B. H. Whitley  
Director  
Regulatory Affairs

**Southern Nuclear Operating Company  
Vogtle Electric Generating Plant Units 3 and 4  
Request for License Amendment and Exemption:  
Shield Building Roof Changes (LAR-16-031)**

**Vogtle Electric Generating Plant (VEGP) Units 3 and 4**

**Figure 3-4: Proposed UFSAR Figure 3H.5-11 Sheet 6 with Item Labels**

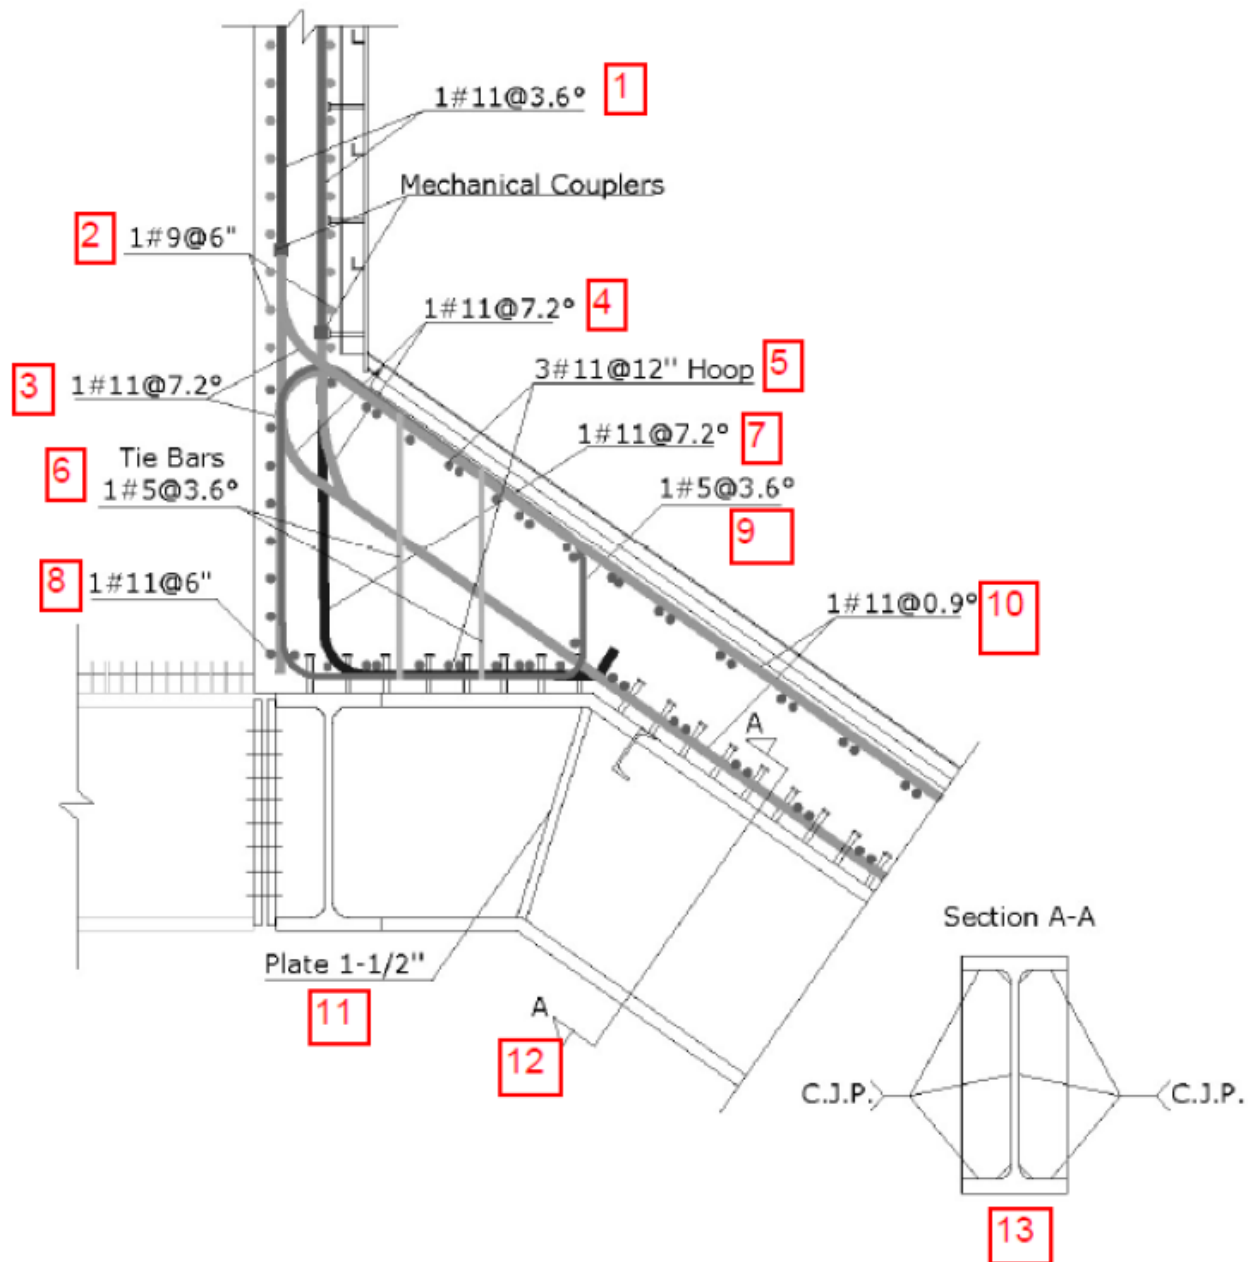
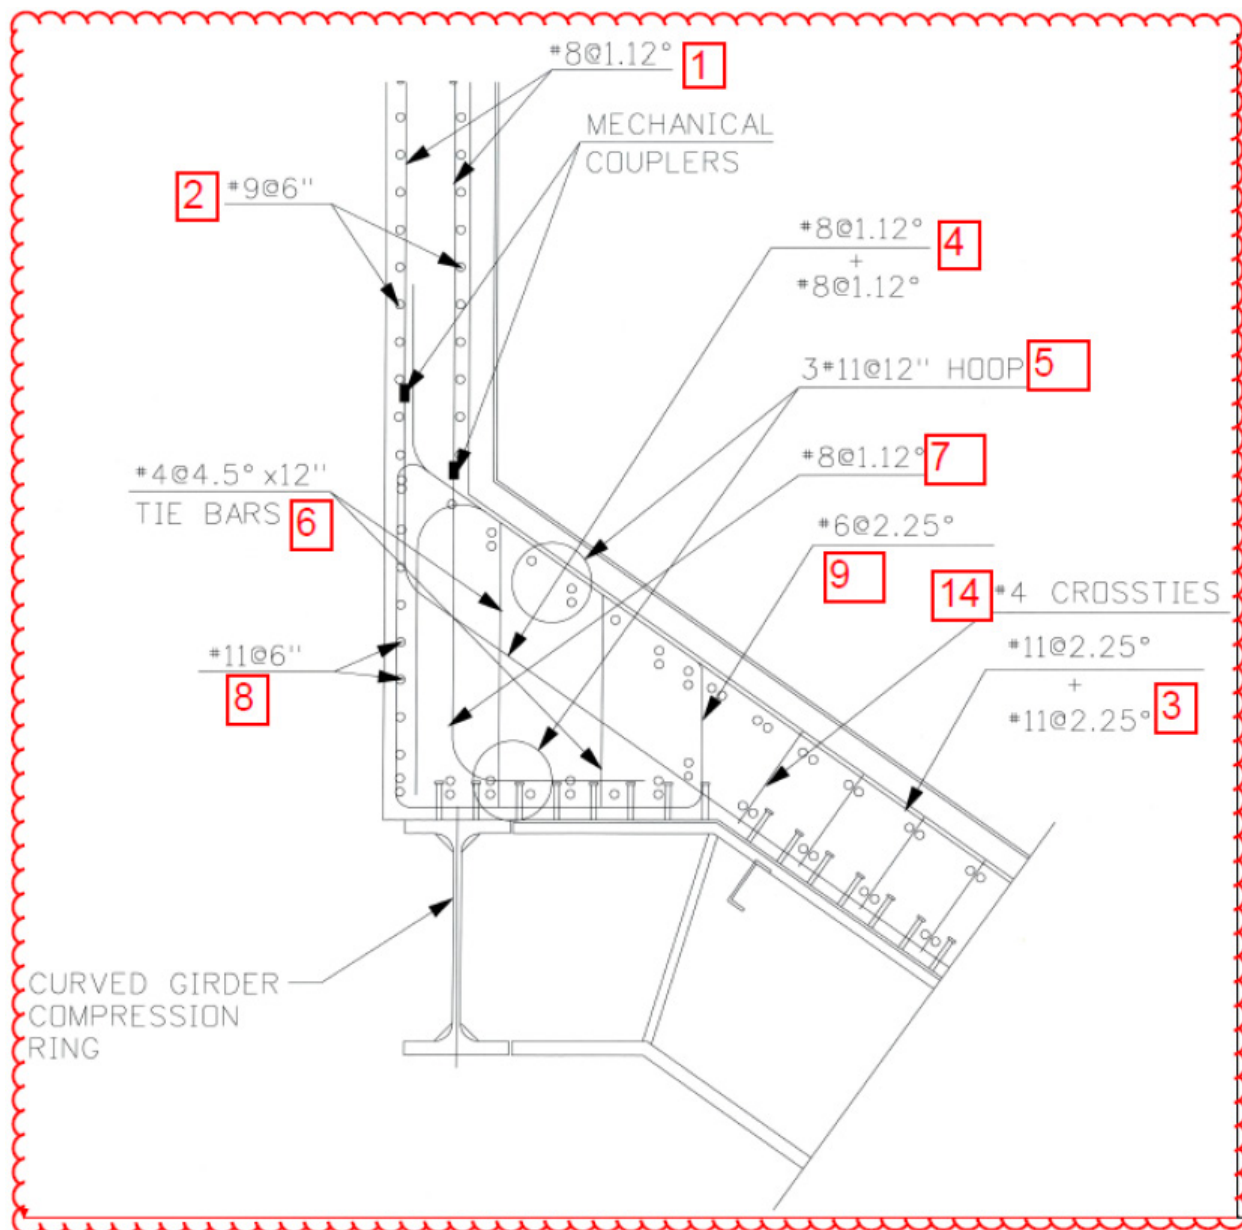
On UFSAR Figure 3H.5-11, Sheet 6 the following changes are made: the vertical reinforcement bars in the tank interior wall are changed from 1 #11 @ 3.6° to #8 @ 1.12°; the top radial reinforcement in the roof slab near the tank interior wall is changed from 1 #11 @ 7.2° to #11 @ 2.25° + #11 @ 2.25°; the bottom radial reinforcement in the roof slab near the tank interior wall is changed from 1 #11 @ 7.2° + 1 #11 @ 7.2° to #8 @ 1.12° + #8 @ 1.12°, and only one set of bottom reinforcement (#8 @ 1.12°) is connected to tank wall vertical reinforcement on the outer face and the other set of bottom reinforcement is developed into the tank wall without connecting the vertical reinforcement at inner face of the tank wall; the layout of 3 #11 @ 12" hoops at the intersection of tank interior wall to roof is changed from 2 #11 (laid out horizontally) + 1 #11 to 2 #11 (laid out vertically) + 1 #11; the tie bars at the intersection of tank interior wall to roof are changed from 1 #5 @ 3.6° to #4 @ 4.5° with 12 inches spacing; the dowels of vertical reinforcement at inner face of the tank interior wall are changed from 1 #11 @ 7.2° to #8 @ 1.12°, and the vertical reinforcement bars at inner face of the tank wall are all connected to the dowels instead of partially connecting to dowels and partially connecting to the bottom radial reinforcement in the roof; the closed stirrups at the intersection of tank interior wall to roof are changed from #5 @ 3.6° to #6 @ 2.25° and enclose the hoop reinforcement on the side surface of the intersection area; the reinforcement of 1 #11 @ 0.9° represented for the top and bottom

radial reinforcement in the roof at half way between the PCS interior and exterior walls is removed as it is not applicable to this figure; the crossties information in the roof slab “#4 crossties” is added to match the design documents. All changes meet the requirements of ACI 349. In order to better visualize the changes in UFSAR Figure 3H.5-11 Sheet 6 one by one, Table 2 is provided below to summarize the changes with item labels. The design elements in both current and proposed UFSAR Figure 3H.5-11 Sheet 6 are labeled with numbers in Figure 3-3, Figure 3-4 below.

Item	Element	Current Figure 3H.5- 11 Sheet 6 (Figure 3-3)	Proposed Figure 3H.5- 11 Sheet 6 (Figure 3-4)	Reasons of the Changes	LAR Change Activities (CA)
1	PCS Tank Interior Wall - Vertical Reinforcement	1 #11 @ 3.6°	#8 @ 1.12°	The amount of the reinforcement is changed due to design finalization.	CA#3
2	PCS Tank Interior Wall - Hoop Reinforcement	1 #9 @ 6"	#9 @ 6"	No changes.	-
3	Roof Slab near PCS Tank Interior Wall - Top Radial Reinforcement	1 #11 @ 7.2°	#11 @ 2.25° + #11 @ 2.25°	The amount of the reinforcement is changed due to design finalization.	CA#3
4	Roof Slab PCS Tank Interior Wall - Bottom Radial Reinforcement	1 #11 @ 7.2° + 1 #11 @ 7.2° & One set of # 11 @ 7.2° is connected to the vertical reinforcement at the outer face of PCS tank wall, and the other set is connected to the vertical reinforcement at the inner face of PCS tank wall	#8 @ 1.12° + #8 @ 1.12° & Only one set of #8 @ 1.12° is connected to the vertical reinforcement at the outer face of PCS tank wall, the other set is developed into the PCS tank wall.	The amount of the reinforcement is changed due to design finalization. The detailing of the reinforcement is revised for ease of construction and does not impact the design of the structure. The development length of the reinforcement meets requirements of ACI 349.	CA#3

Item	Element	Current Figure 3H.5- 11 Sheet 6 (Figure 3-3)	Proposed Figure 3H.5- 11 Sheet 6 (Figure 3-4)	Reasons of the Changes	LAR Change Activities (CA)
	– Top and Bottom Hoop Reinforcement	#11 (laid out horizontally) + 1 #11	#11 (laid out vertically) + 1 #11	unchanged. The 2 #11 is laid out vertically instead of horizontally as it eases installation of reinforcement.	
6	PCS Tank Interior Wall to Roof Intersection – Tie Bars	Tie Bars 1 #5 @ 3.6°	#4 @ 4.5° x 12" TIE BARS	The amount of the reinforcement is changed due to design finalization.	CA#3
7	PCS Tank Interior Wall – Dowels of Vertical Reinforcement at Inner Face of the Tank	1 #11 @ 7.2° & Half of the vertical reinforcement in the tank interior wall is developed through the dowel, and the other half set is connected to the bottom radial reinforcement in the roof slab.	#8 @ 1.12° & All of the vertical reinforcement in the tank wall is developed through the dowel.	To correspond to the changes made in item 1. All vertical reinforcement at the inner face of the PCS tank wall are developed through the dowels for ease of construction and does not impact the design of the structure.	CA#3

Item	Element	Current Figure 3H.5- 11 Sheet 6 (Figure 3-3)	Proposed Figure 3H.5- 11 Sheet 6 (Figure 3-4)	Reasons of the Changes	LAR Change Activities (CA)
			interior wall to roof intersection	does not impact the design of the structure.	
10	Roof Slab - Top and Bottom Radial Reinforcement	1 #11 @ 0.9°	Removed	It represents roof radial reinforcement at half way between the PCS interior and exterior walls, and is not applicable to this detail.	CA#3
11, 12, 13	Detailed Information	See Figure 3- 3	Removed	The information is beyond the level of detail of the UFSAR figure.	CA#4C
14	Roof Slab - Crossties	None	#4 CROSSTIES	The crossties in the roof slab are part of the design and always existed in the design documents. The UFSAR figure is updated to match the design documents.	CA#3

6. Revise reinforcement design details on Sheet 5. CA#3, CA#4C
7. Revise reinforcement design details on Sheet 6. CA#3, CA#4C

**UFSAR Figure 3H.5-14 Elevation View of Tension Ring and Air Inlets - Revise information as shown below.**

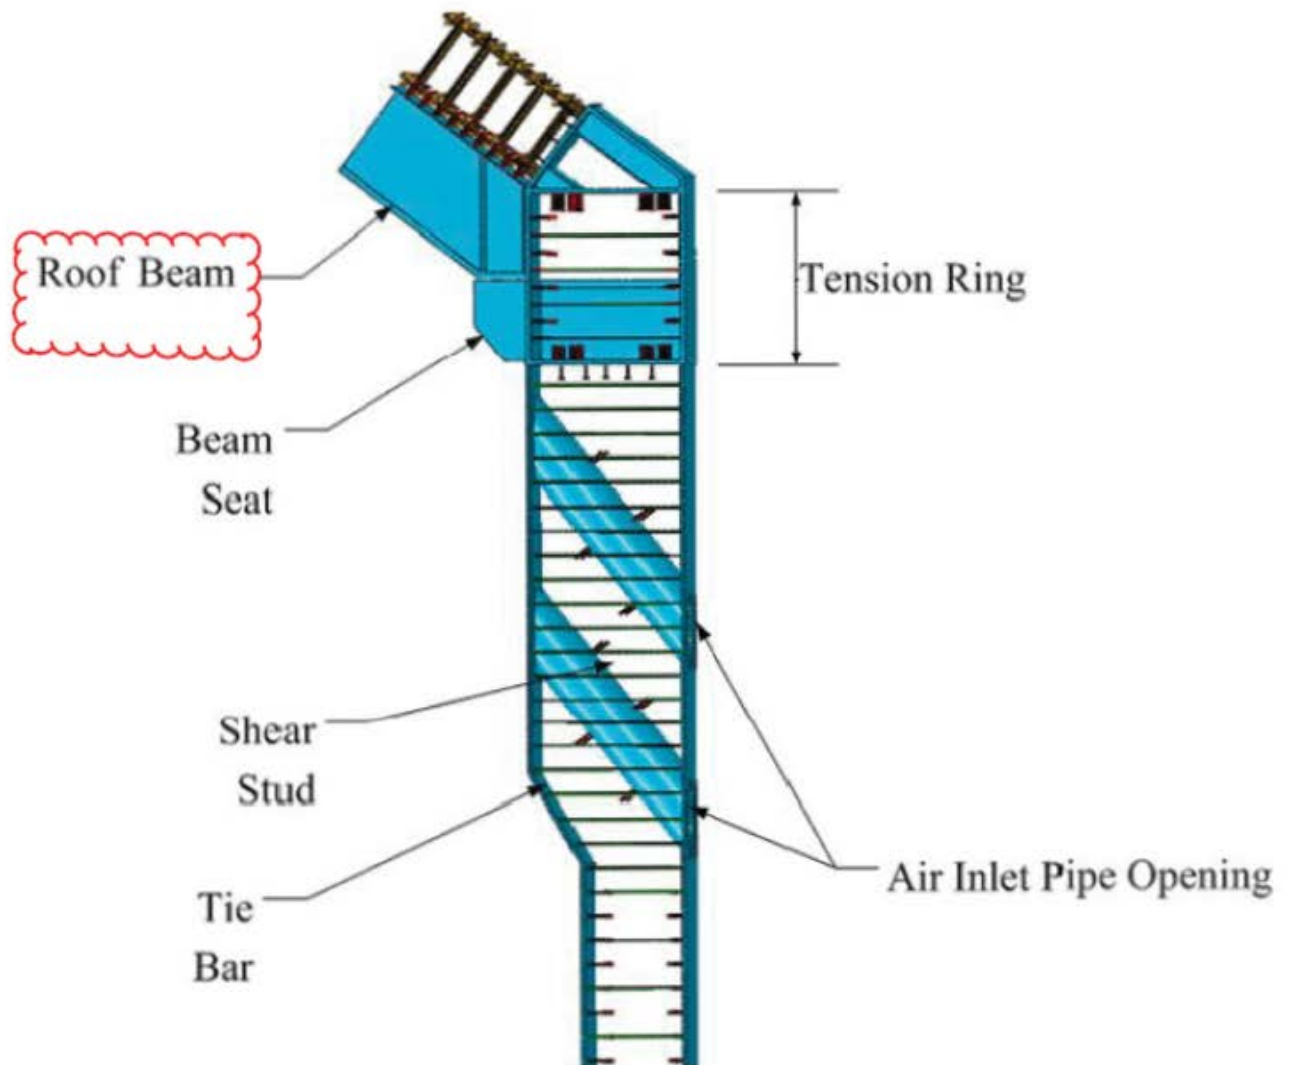
- Remove reference to beam size. CA#1
- Change roof beam designation. CA#4F

**UFSAR Figure 3H.5-15 Shield Building Tension Ring - Revise information as shown below.**

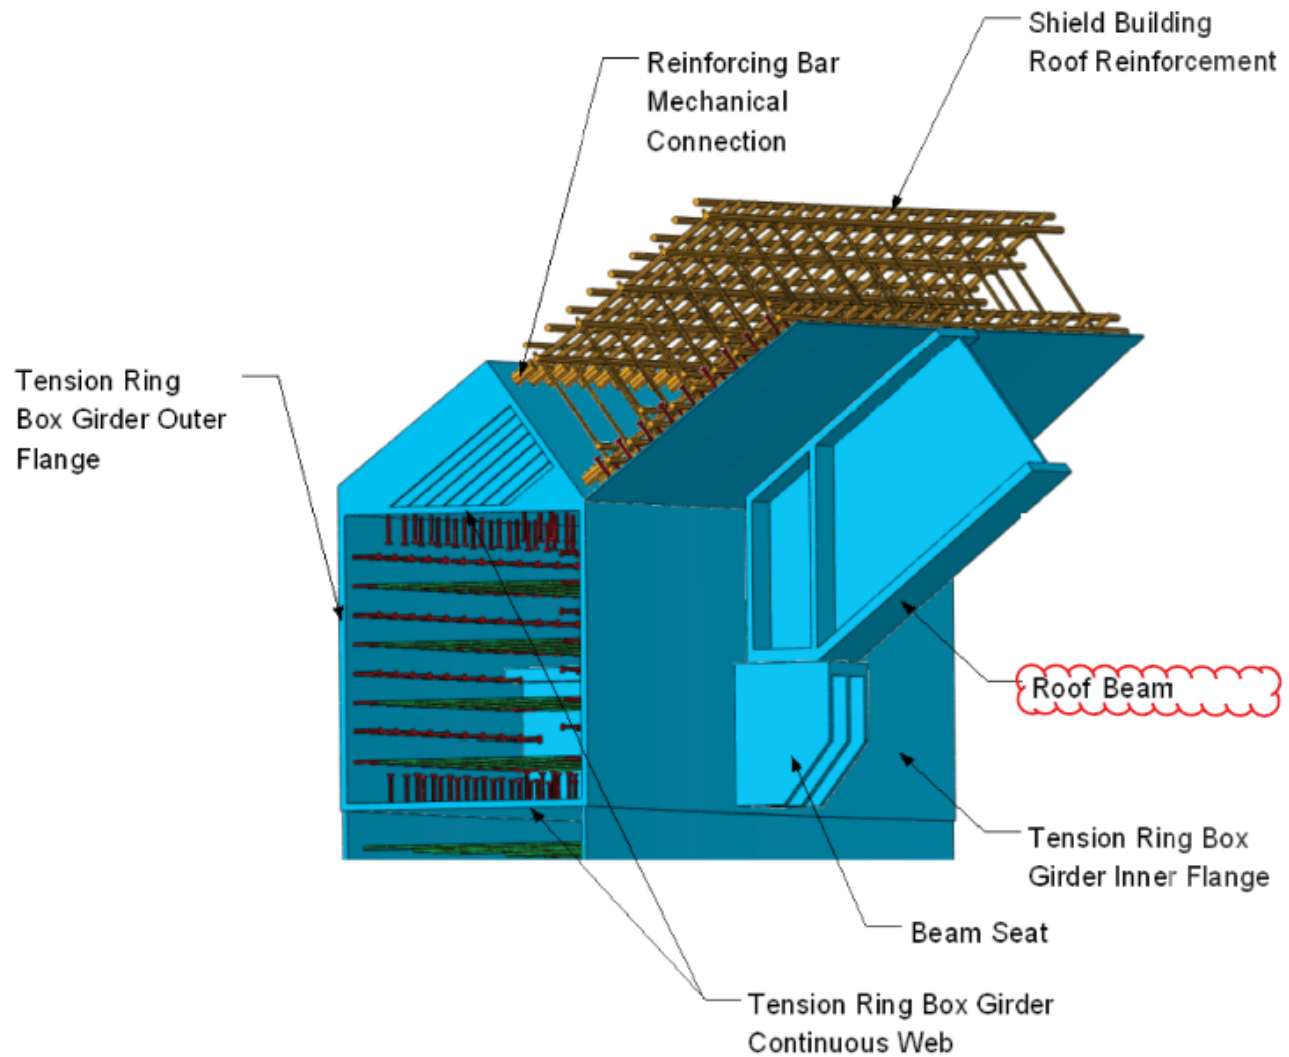
- Remove reference to beam size. CA#1
- Change roof beam designation. CA#4F

**UFSAR Table 3H.5-9 (Sheet 1 of 3) Shield Building Roof Reinforcement Summary (Tension Ring) - Revise information as shown below (figure blow-up is shown on the following pages).**

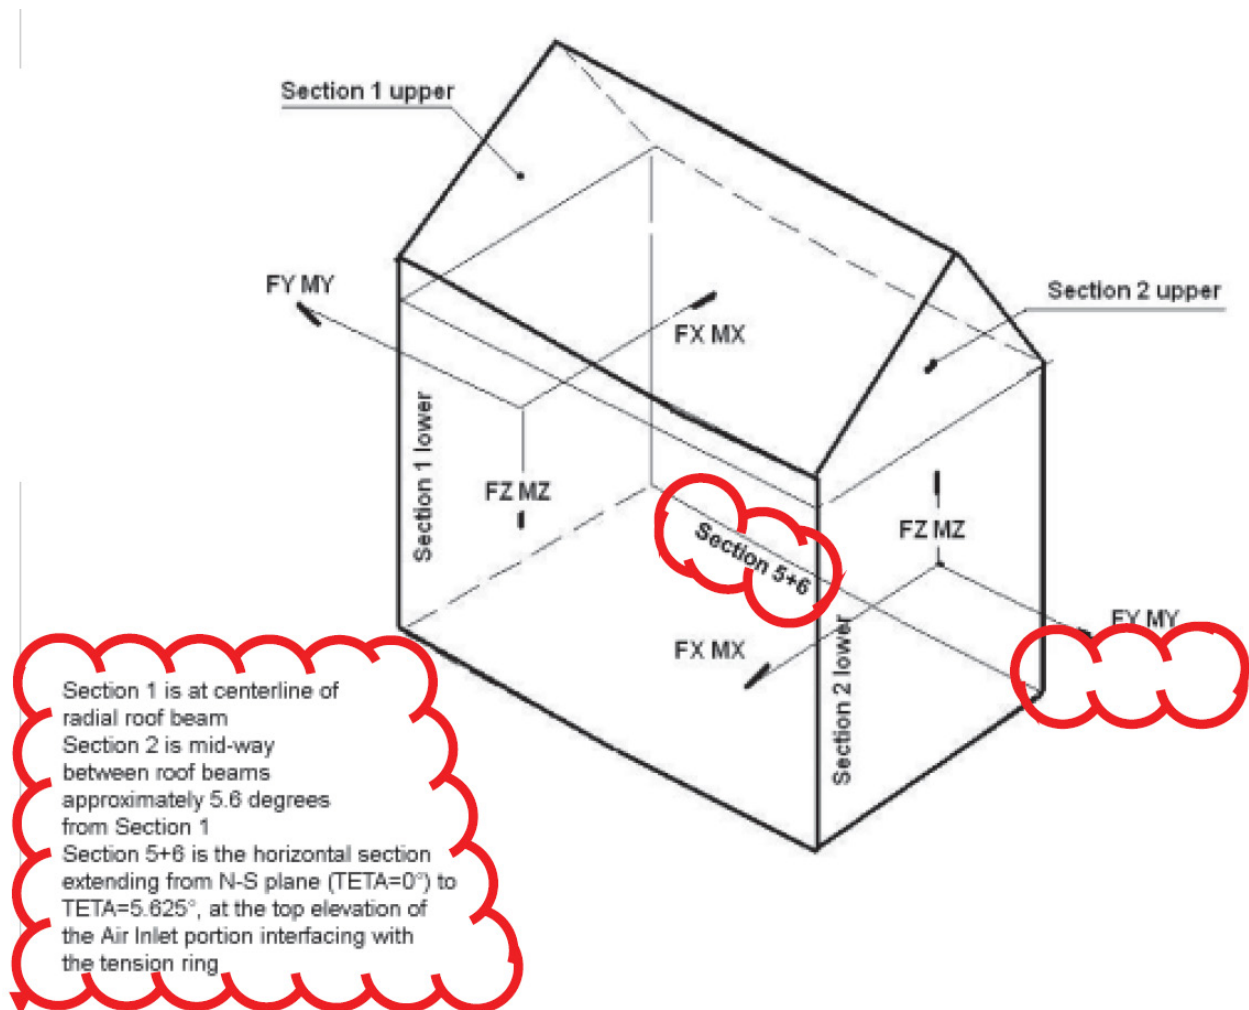
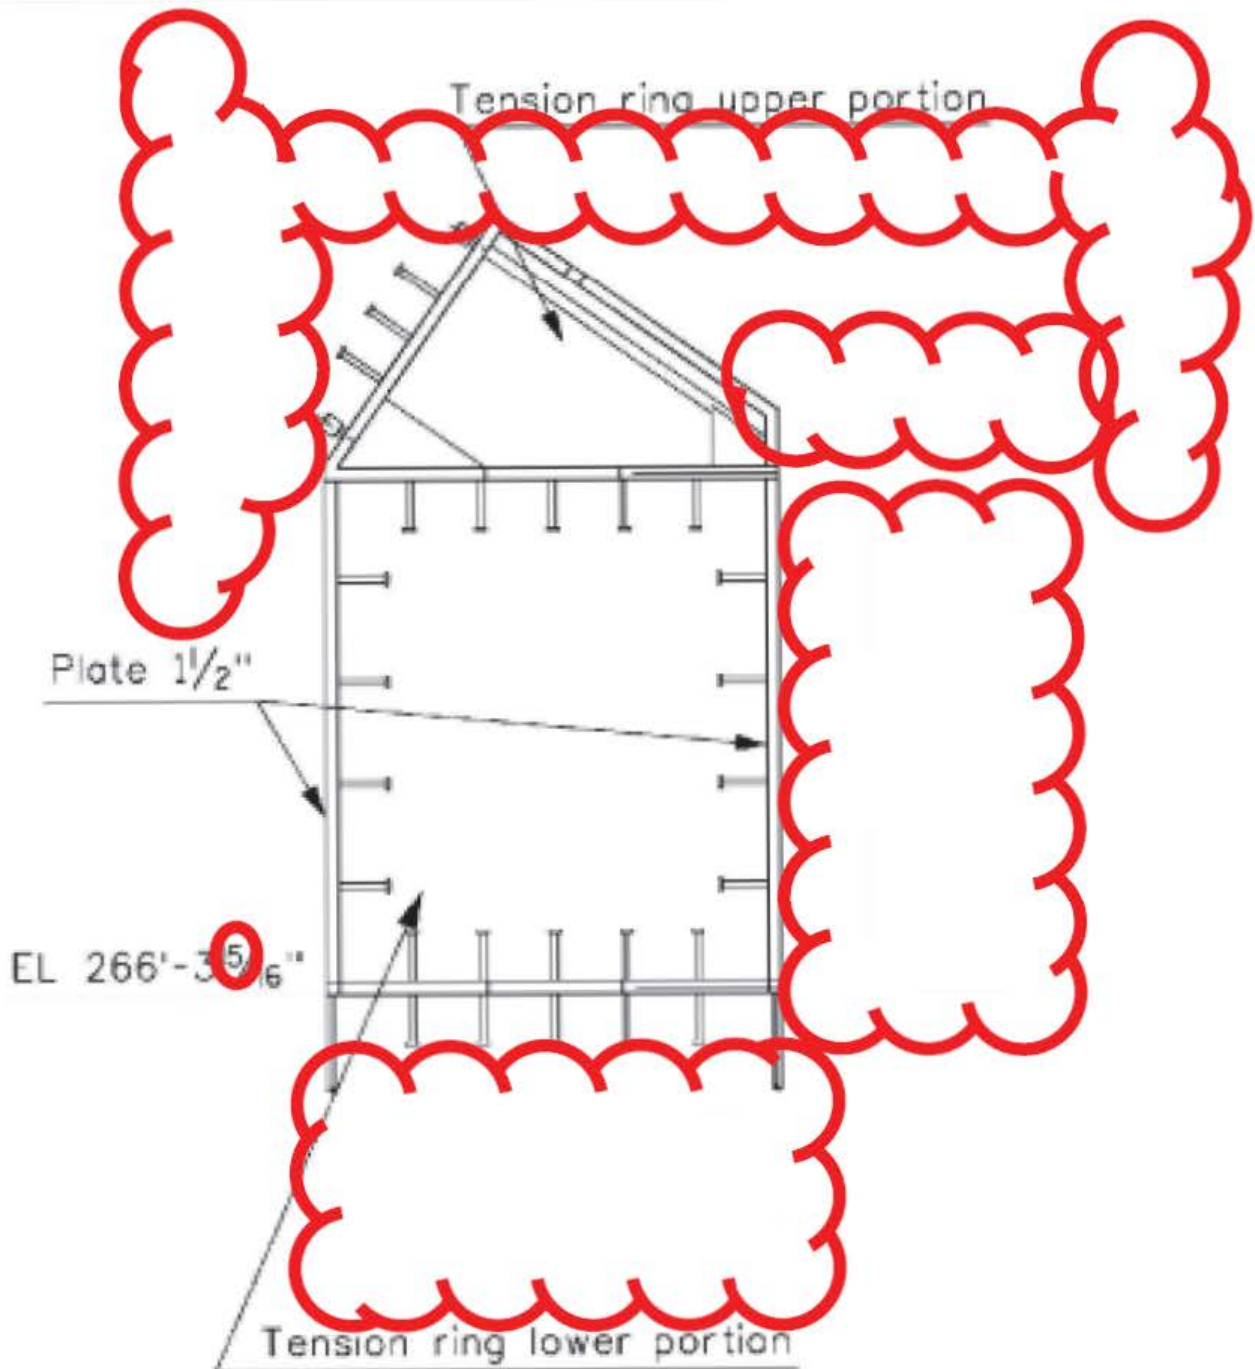
Revise the values in UFSAR Table 3H.5-9 Sheet 1 for the tension ring for maximum stress at specified location and maximum overall, the steel required, and the ratio of required over provided. Revise the values in UFSAR Table 3H.5-9 Sheets 2a, 2b and 2c for the air inlet structure for maximum steel area required at specified locations and maximum overall, steel area provided, and design limit for reinforcement ratios. Revise the values in UFSAR Table 3H.5-9 Sheet 3 for the wall of the PCCWST for maximum required reinforcement, provided reinforcement and design limit for reinforcement ratios. In some cases governing load combinations identified in the table are changed. On UFSAR Table 3H.5-15, revise the values for required reinforcement, provided (minimum) vertical and radial reinforcement, and reinforcement ratio for the shield building roof reinforcement. The changes to the table are

required to make the values consistent with the proposed reinforcement design changes to satisfy detailing requirements and changes to demands in the structural analysis. The changes of demands are the results of the design finalization, including design changes in previous License Amendment Requests and calculation updates. The calculations are performed based on updated loads and meet the requirements of applicable codes. Irrespective of the magnitude of each load change, the demands were found to be smaller than the capacities. The design of the shield building roof with the changes to the reinforcement and roof beams satisfies applicable provisions of AISC N690 and ACI 349. The criteria and requirements of ACI 349 and AISC N690 provide a margin of safety to structural failure, therefore the proposed changes do not raise any safety concerns of the structure.

1. Revise values in table and the numbers of governing load combinations. CA#3
2. Remove dimensions from the locator figures. CA#4A
3. Add a legend to the table sketches to identify the location of the sections. CA#4A
4. The tie bar is renamed. CA#4D
